DESERT BREEZE SOLAR PROJECT

FINAL ENVIRONMENTAL IMPACT REPORT

SCH# 2022090646

JANUARY 5, 2024

REVISED FIGURE 3-5: Land Use

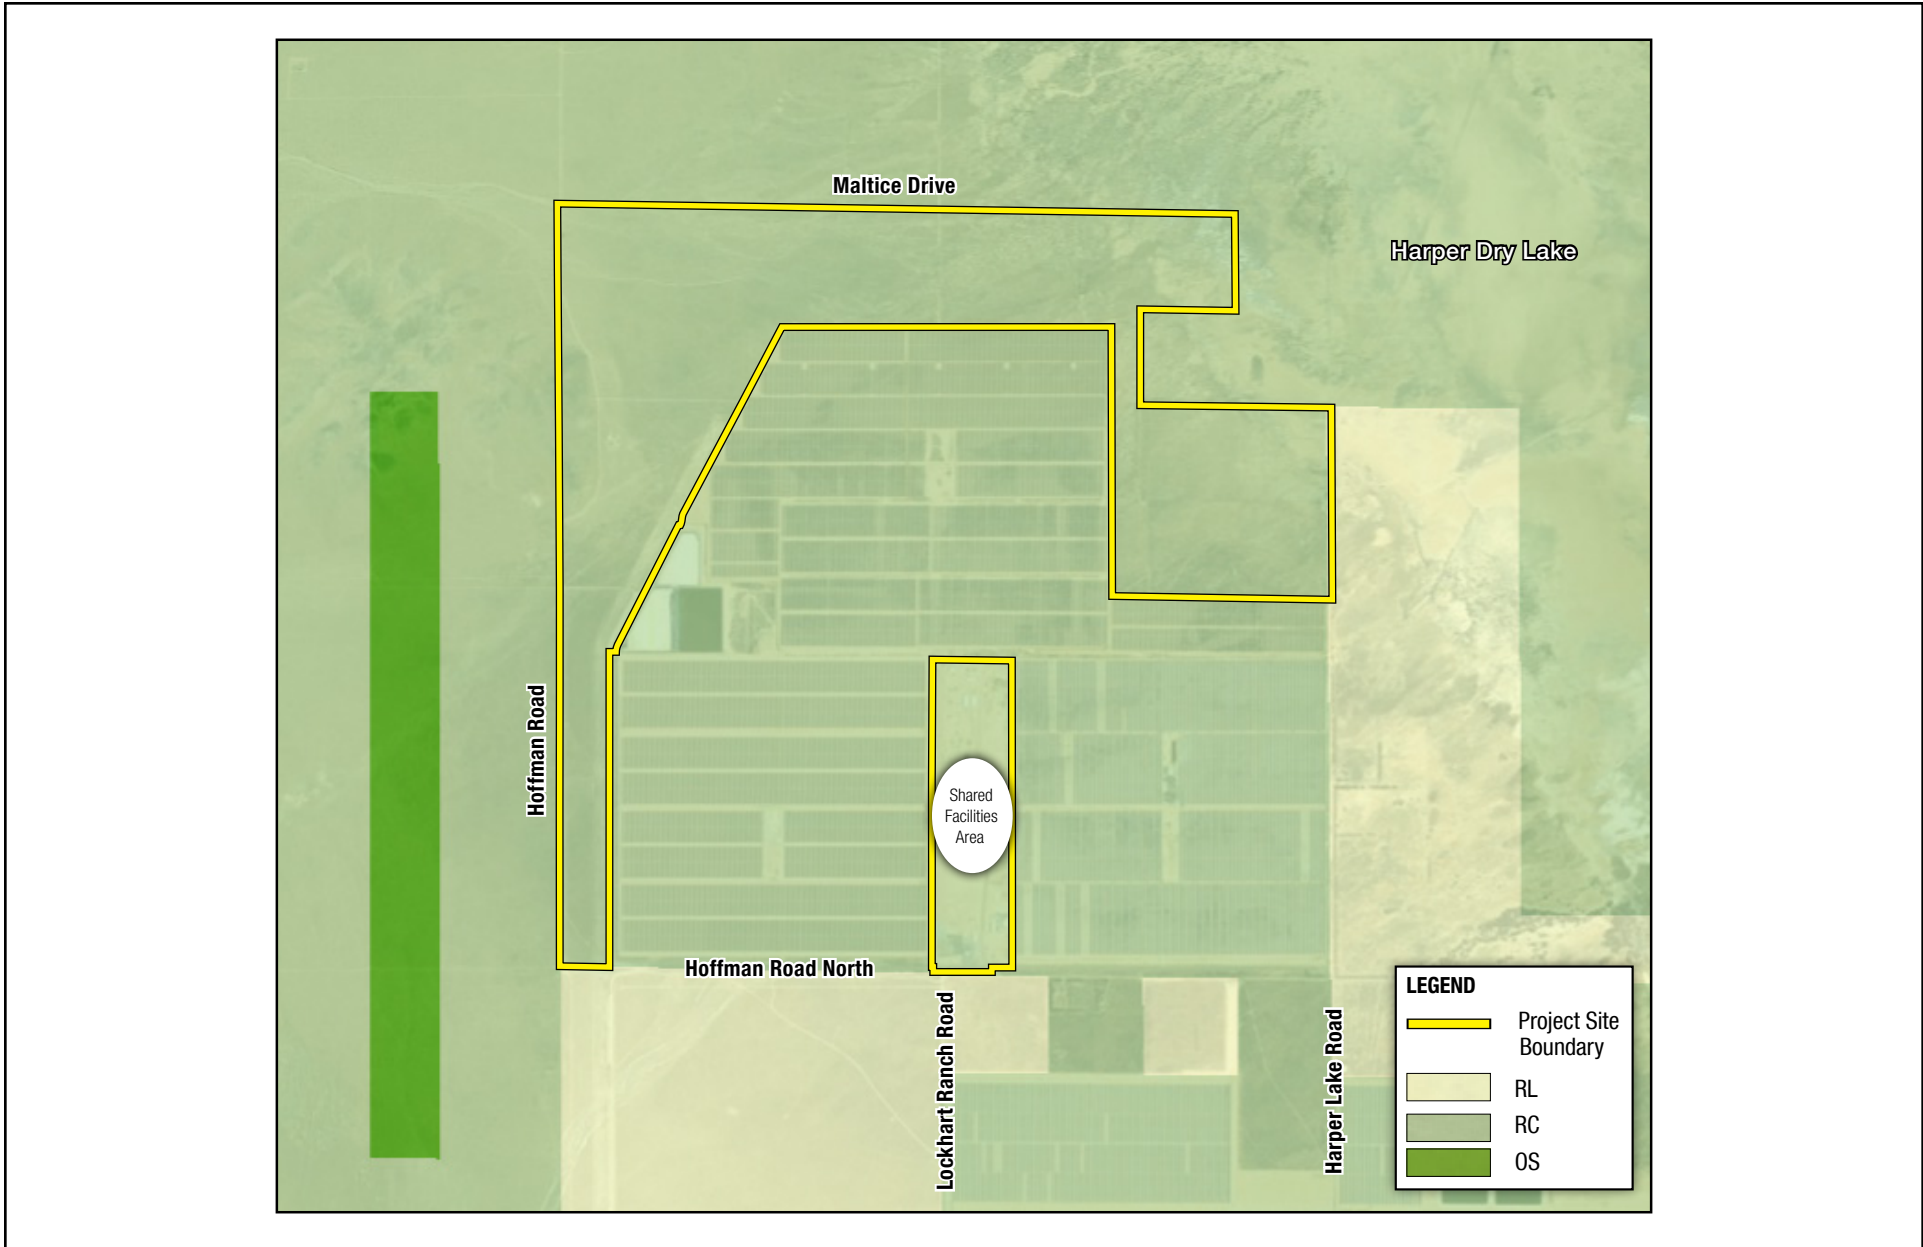
4. Page 3-9, **Figure 3-5: Land Use** is revised below.
